UNITED STATES
NUCLEAR REGULATORY COMMISSION
WASHINGTON, D. C. 20555

DRESDEN STATION UNIT NO. 2

AMENDMENT TO PROVISIONAL OPERATING LICENSE

Amendment No. 39
License No. DPR-19

Minimum Temperature Requirements per Appendix G of 10 CFR 50

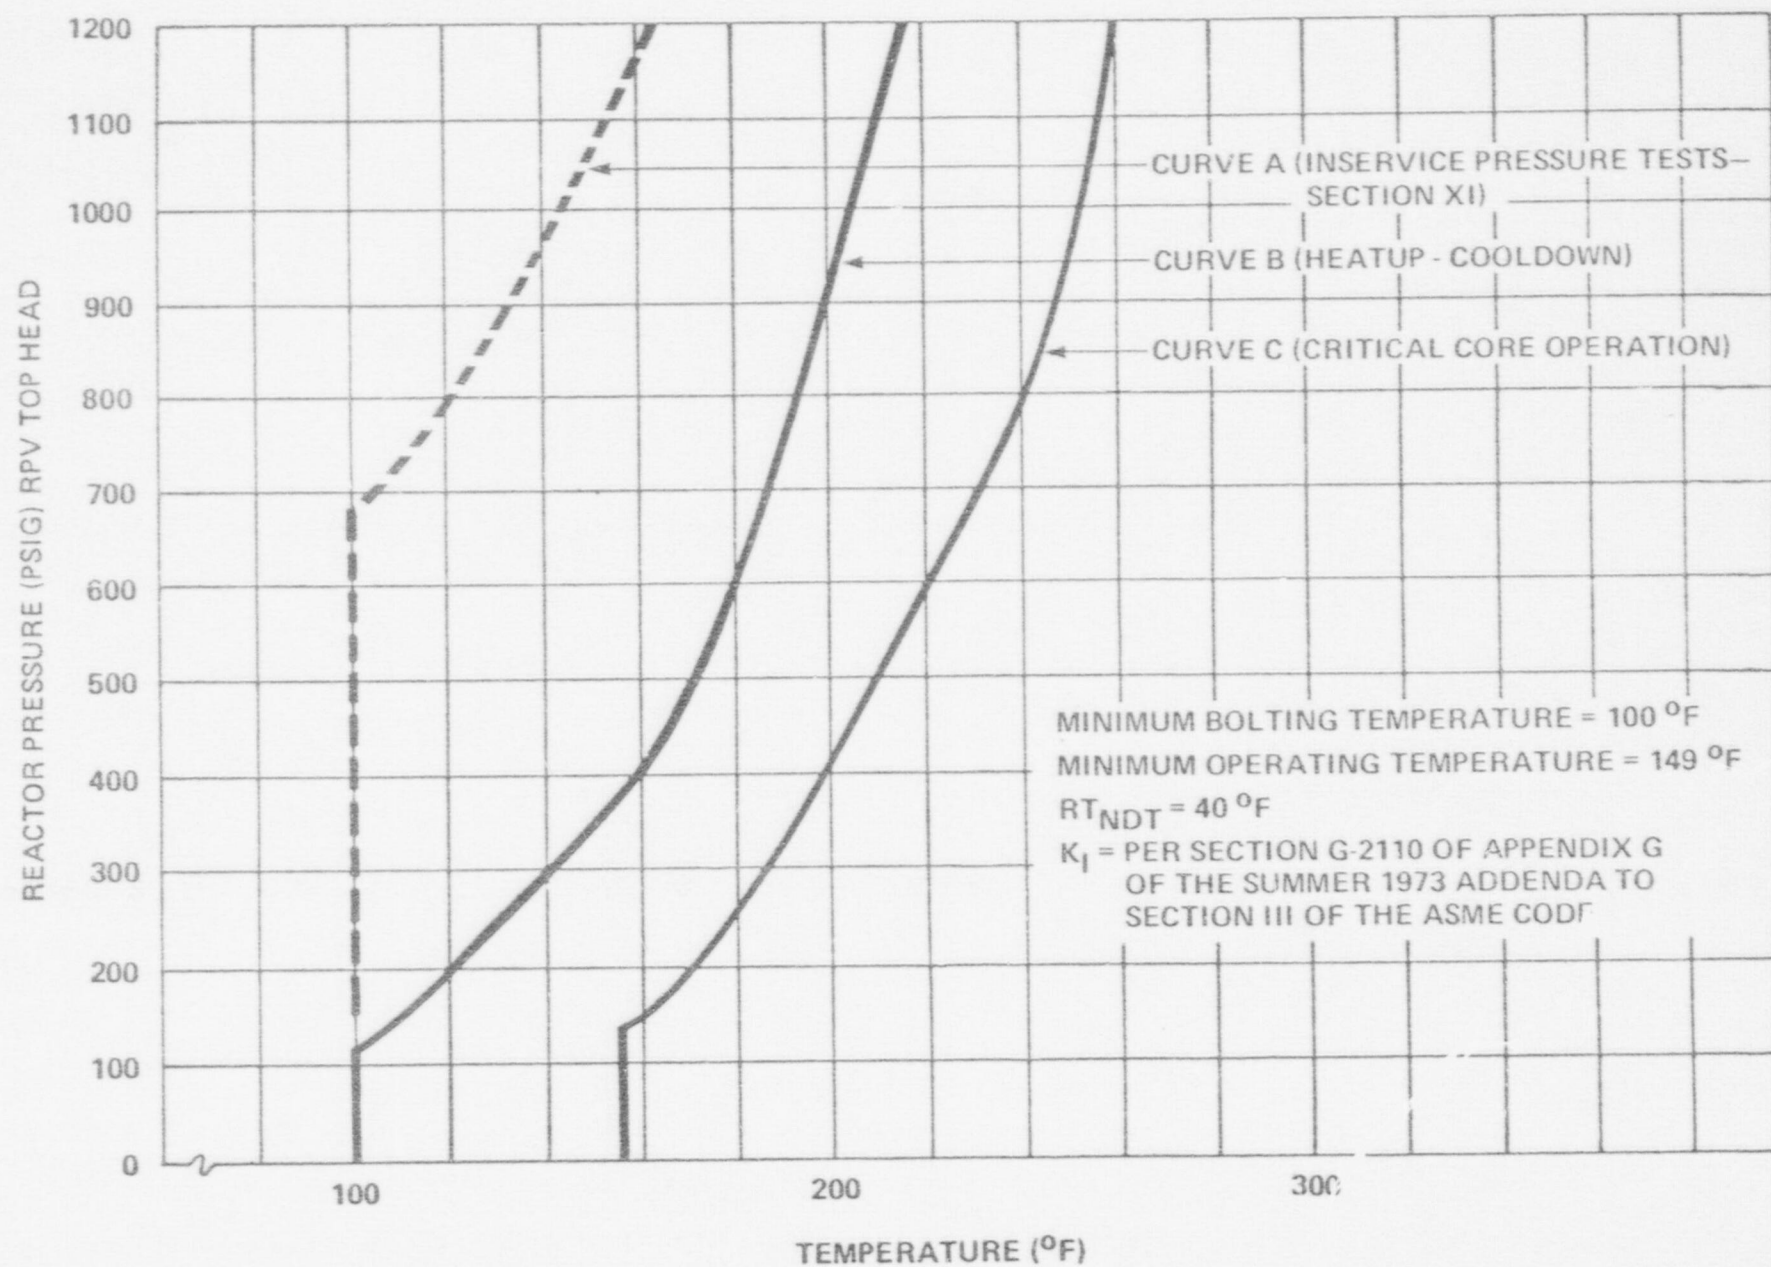
1. The reactor vessel shall be vented and power operation shall not be conducted unless the reactor vessel temperature is equal to or greater than that shown in Curve C of Figure 3.6.1. Operation for hydrostatic or leakage tests, during heatup or cooldown, and with the core critical shall be conducted only when vessel temperature is equal to or above that shown in the appropriate curve of Fig. 3.6.1. Figure 3.6.1 is effective through 6 effective full power years. At least six months prior to 6 effective full power years new curves will be submitted.
2. The reactor vessel head bolting studs shall not be under tension unless the temperature of the vessel shell immediately below the vessel flange is $\geq 100^{\circ}\text{F}$.

Pressurization Temperature - The reactor coolant system is a primary barrier against the release of fission products to the environs. In order to provide assurance that this barrier is maintained at a high degree of integrity, restrictions have been placed on the operating conditions to which it can be subjected. These restrictions on inservice hydrostatic testing, on heatup and cooldown, and on critical core operation shown in Figure 3.6.1, were established to be in conformance with Appendix G to 10 CFR 50.

The initial RT_{NDT} of the main closure flange, the shell and head materials connecting to these flanges, and connecting welds is 100°F . However, the vertical electrosag welds which terminate immediately below the vessel flange have an RT_{NDT} of 40°F . Reference Appendix F to the FSAR. The closure flanges and connecting shell materials are not subject to any appreciable neutron radiation exposure, nor are the vertical electrosag seams. The flange area is moderately stressed by tensioning the head bolts. Therefore, as is indicated in curves (a) and (b) of Figure 3.6.1, the minimum temperature of the vessel shell immediately below the vessel flange is established as 100°F below a pressure of 400 psig. ($40^{\circ}\text{F} + 60^{\circ}\text{F}$, where 40°F is the RT_{NDT} of the electrosag weld and 60°F is a conservatism required by the ASME Code). Above approximately 400 psig pressure, the stresses associated with pressurization are more limiting than the bolting stresses, a fact that is reflected in the non-linear portion of curves (a) and (b). Curve (c), which defines the temperature limitations for critical core operation, was established per Section IV 2.c. of Appendix G of 10CFR50. Each of the curves, (a), (b) and (c) define temperature limitations for unirradiated

ferrectic steels. Provision has been made for the modification of these curves to account for the change in RT_{NDT} as a result of neutron embrittlement.
